Subject: NOISE FROM FUEL TANK INSULATOR	Bulletin No: 01-010/15
	Last Issued: 05/26/2015

2010-2015 CX-9 vehicles produced before April 1, 2015

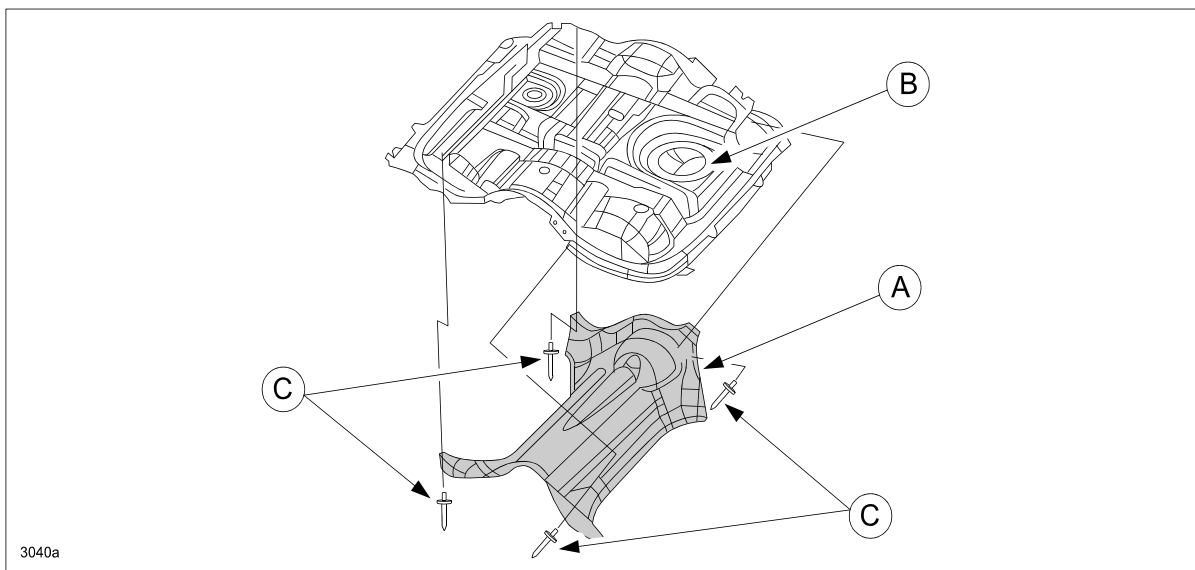
Some vehicles may exhibit an unusual noise while driving the vehicle. The noise may be caused by a broken fuel tank (B) insulator (A) that is hanging down and contacting the propeller shaft.

The rivets (C) may break when a load occurs. The rivet material has been changed to eliminate this concern. Customers having this concern should have their vehicle repaired using the following repair procedure.

5. Install the new insulator with modified rivets.
